Illustrated Parts List - IPL Update

365 X-TORQ

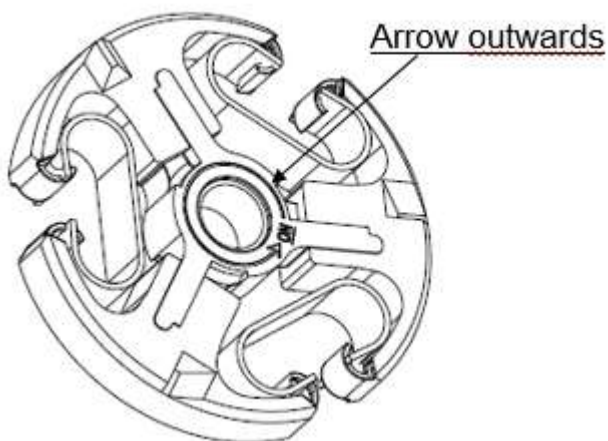
1. New Ignition module. Component update. This update does not **solve** misfire when using the decompression valve. An improvement for this will come later.
2. New Clutch with higher specification.
3. Sleeve to cylinder cover. Available as separate spare part
